R11SU

**SUBJECT: RECALL R11SU FMVSS 221 JOINT STRENGTH NONCOMPLIANCE-
ADHESIVE OMITTED AT 20 GAUGE OUTSIDE SIDE
PANEL JOINTS**

FMVSS 221 Joint Strength Noncompliance Adhesive Omitted on 20 Gauge Outside Side Panels

**Models Affected: 2010 Model Year All American (D3) Model School Buses
with Optional 20 Gauge Outside Side Panels**

Photo 1
Spacing from bottom edge of window line rub rail to floor line.

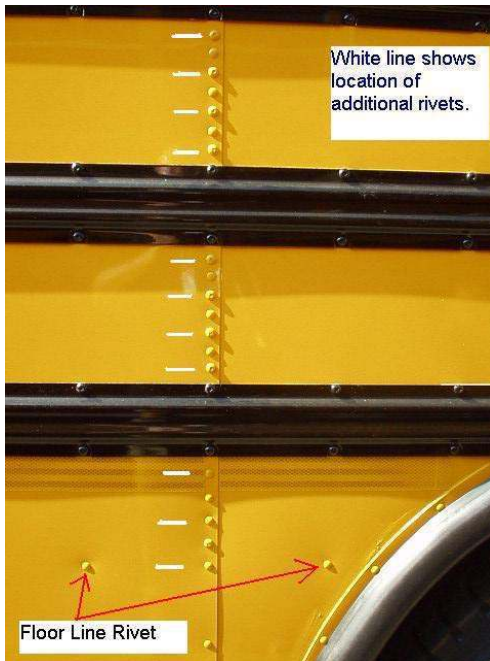
Adhesive required to meet FMVSS 221 Joint Strength requirements may have been omitted at 20 gauge outside side panel joints.

- Using a 17/64" drill bit, drill additional rivet holes at each outside side panel joint as indicated by white dash line in Photo #1 below. A drill stop set at 1/2" (0.50) must be used to prevent possible damage to wires in bow cavities. Be sure holes are evenly spaced between existing rivets and that holes stay in line with existing rivets.

- Install part number #01854397 Rivet, Blind, .25 Dia, .38 grip, in each hole drilled using a rivet gun/tool.
- On the street side of the bus, remove the stop arm to allow installation of the additional rivets in beltline area, then reinstall stop arm.
